Key Highlights from Input &  Event	02
Alternative Concept I and II	
Summary	02
Trailhead Options	
Summary	04
USFS Preferences	
Summary	07

### Key Highlights from Input and Event

### ▶ Alternative I and II Concepts Summary

# Alternative Concept II

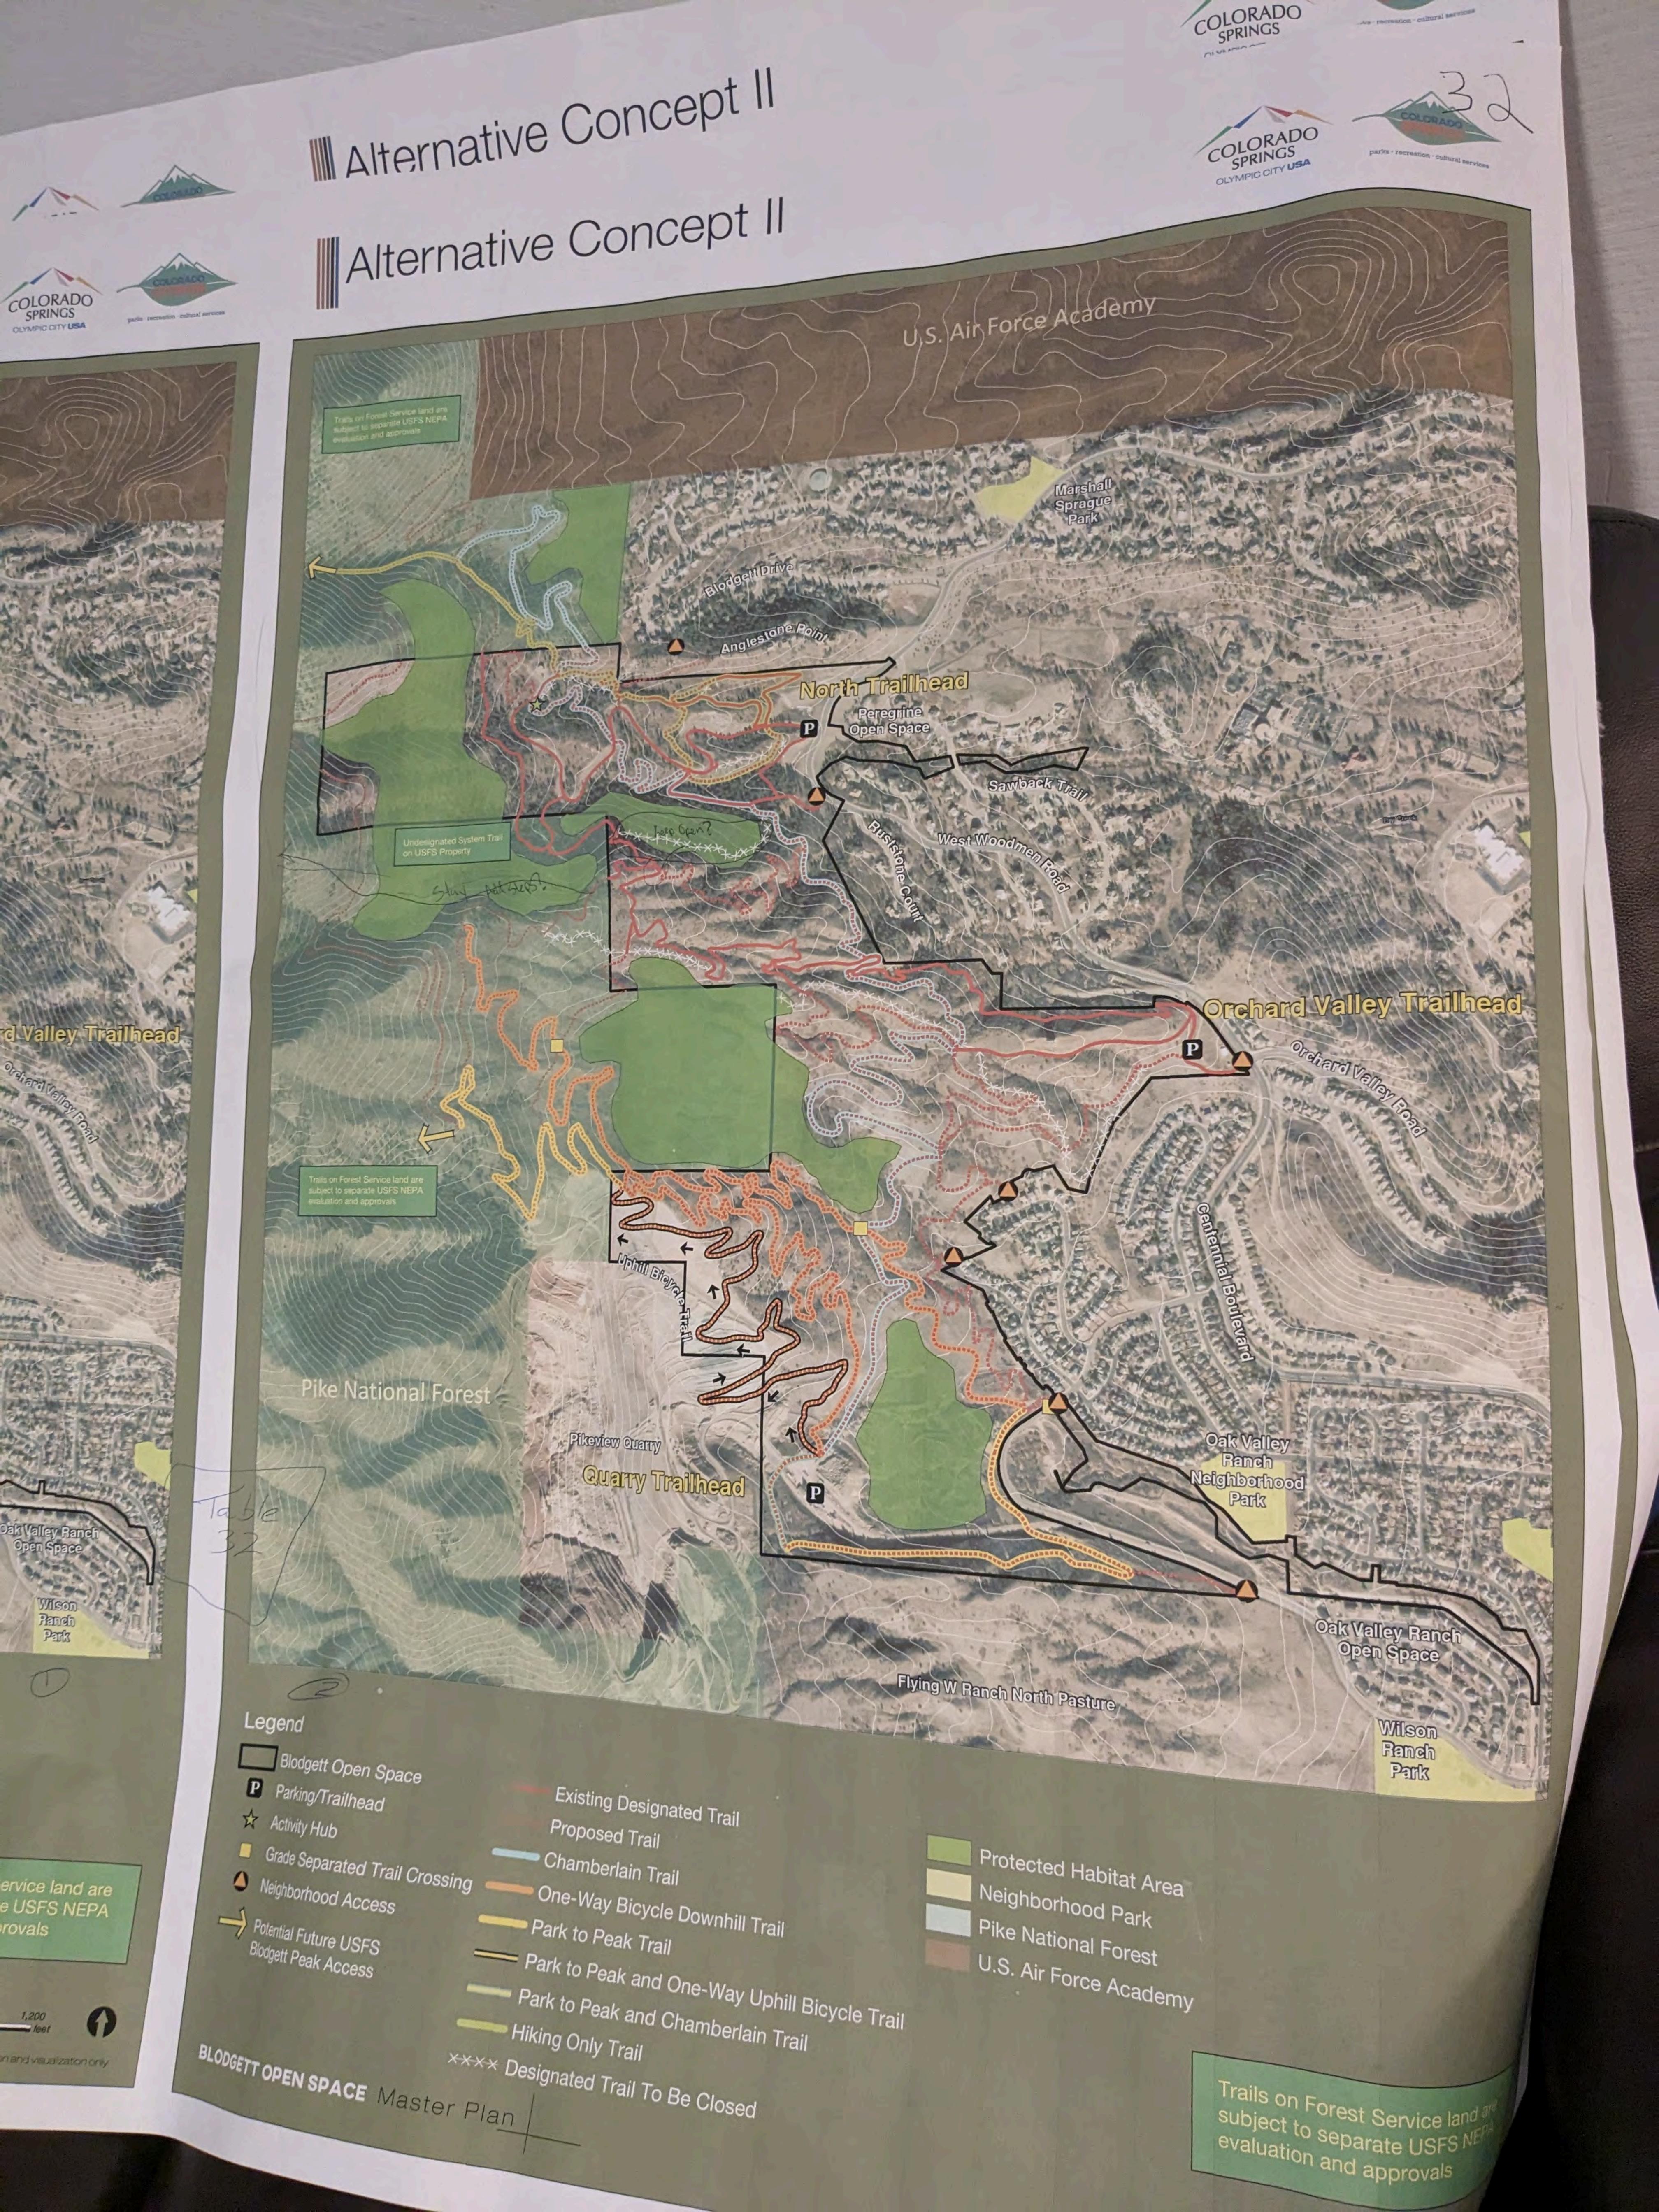
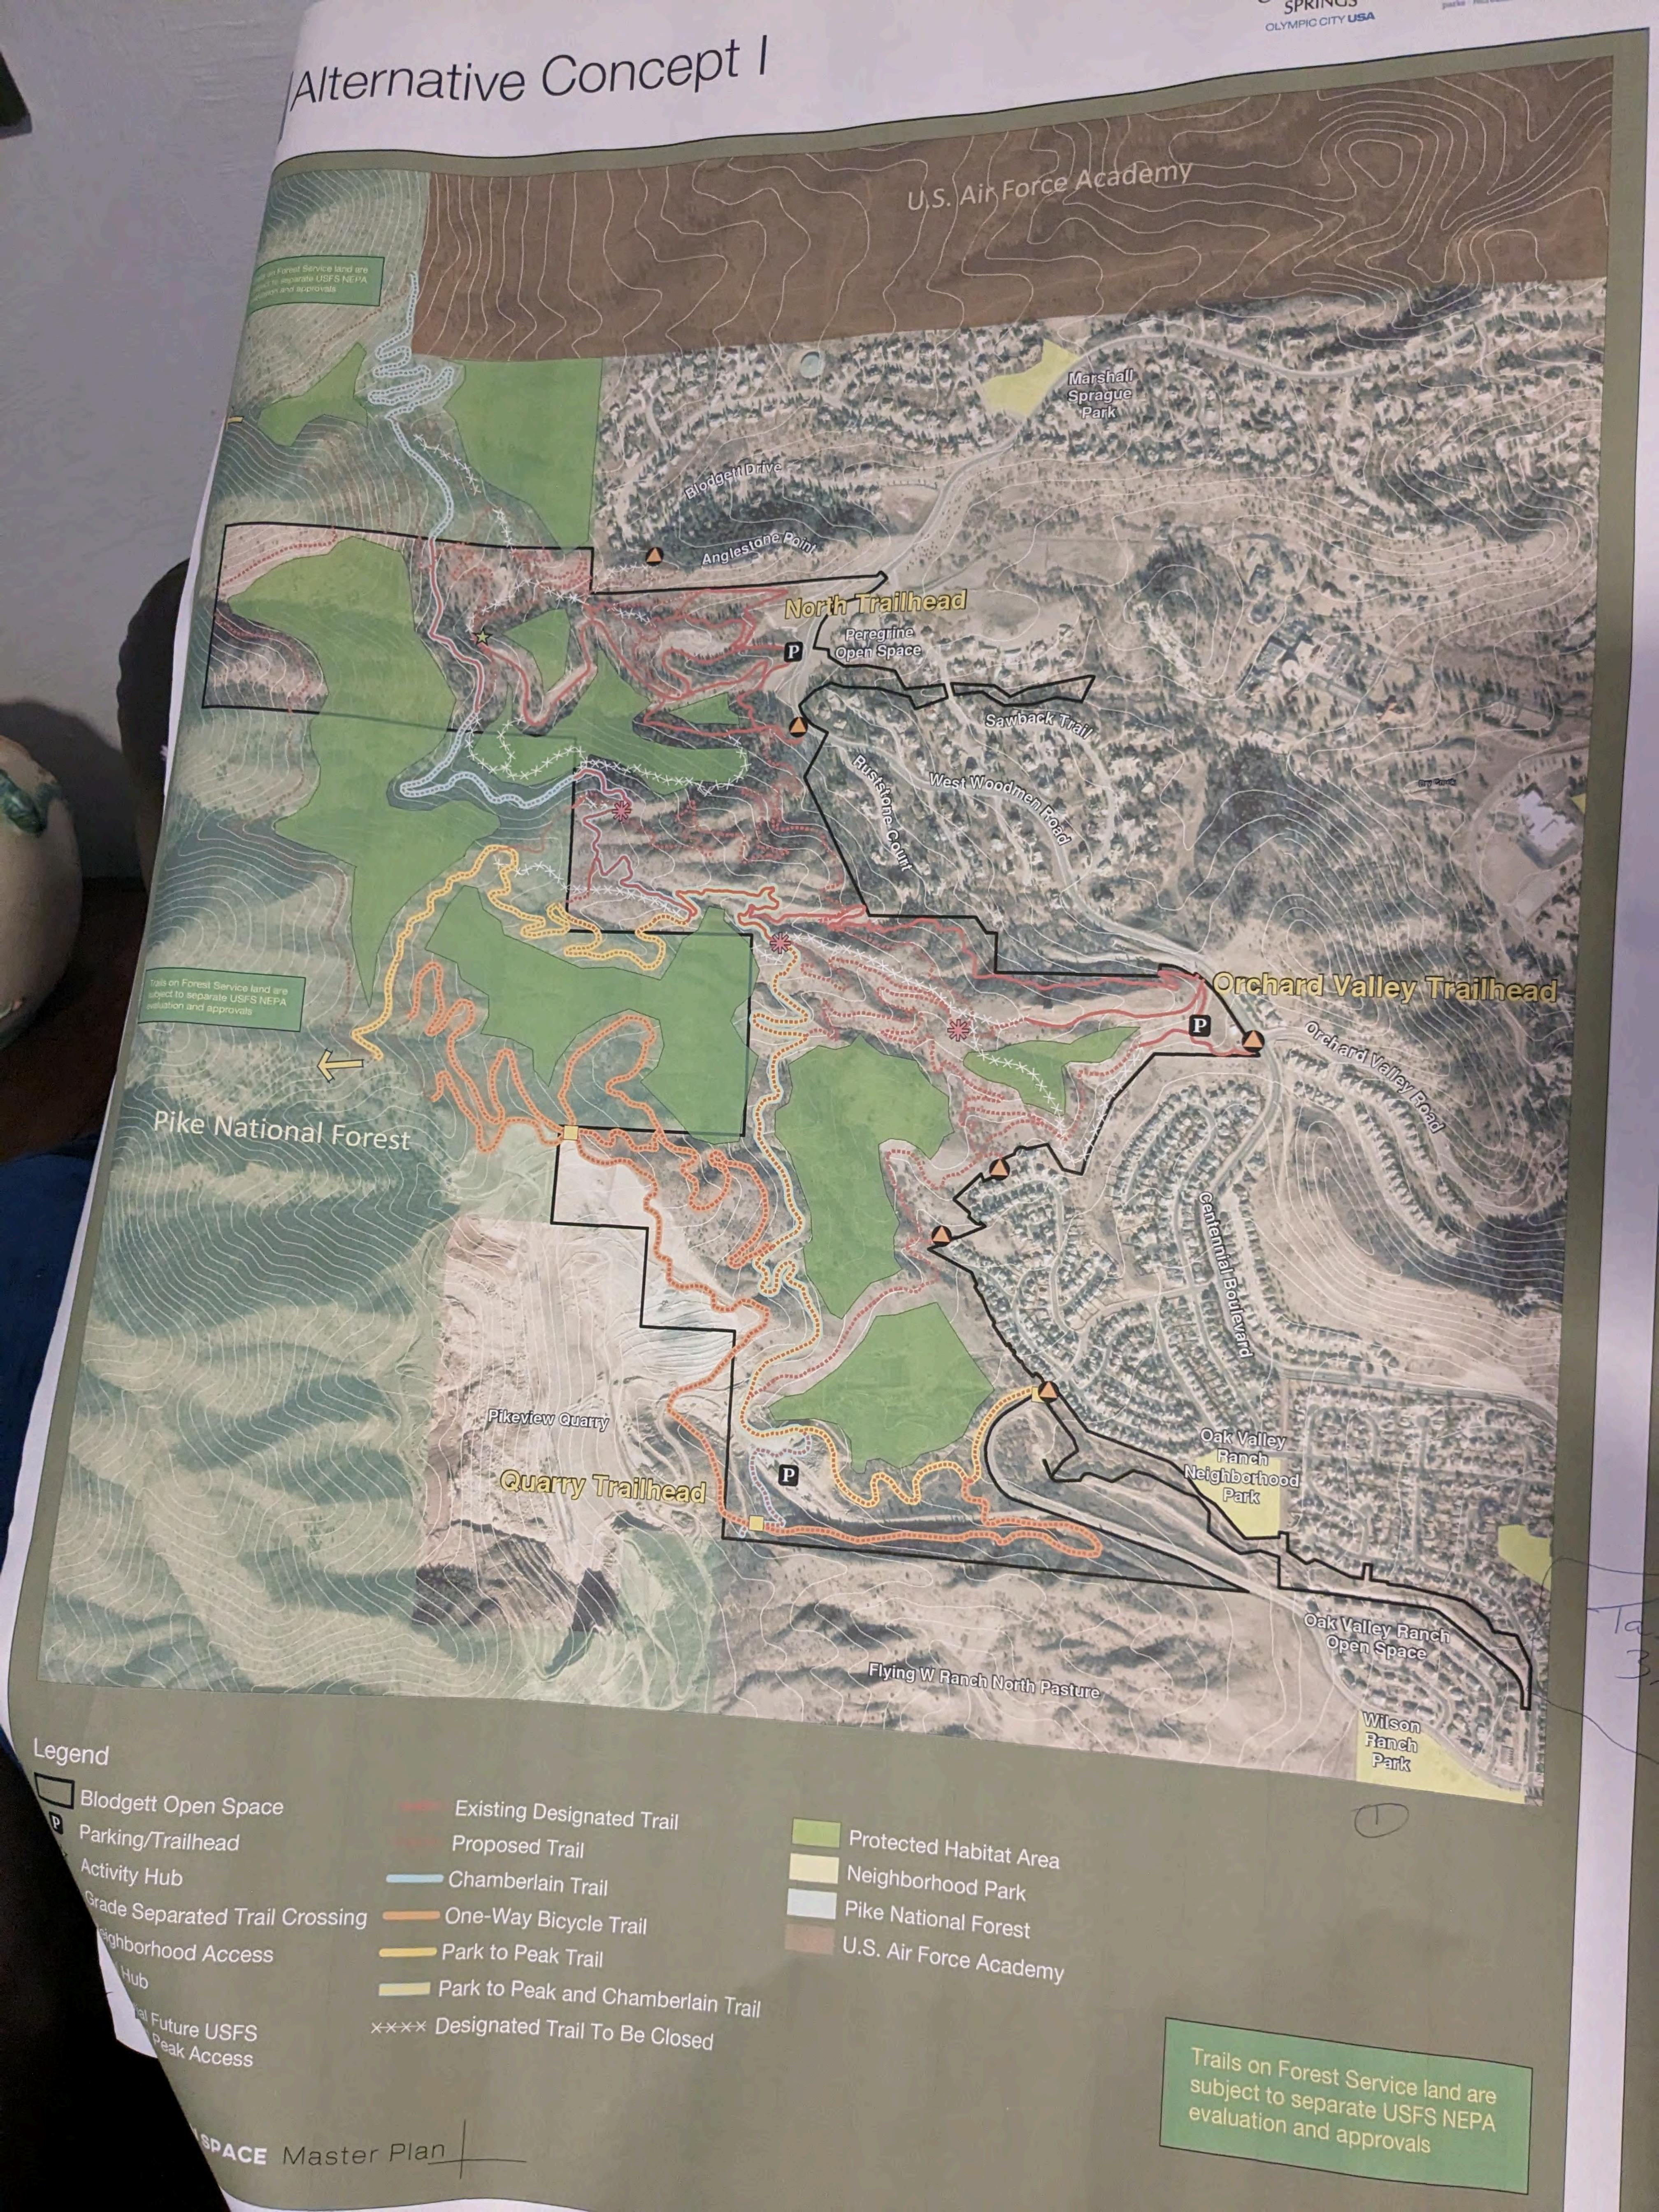
We have the following concerns about the Alternative Concept II:

Speci	110 0011001111
6	thrastructure needs must be addressed
7	Dor neighborhoods are the priority of
8	Safety for the Children and Wildlife
9	safety for the Children and whater
10
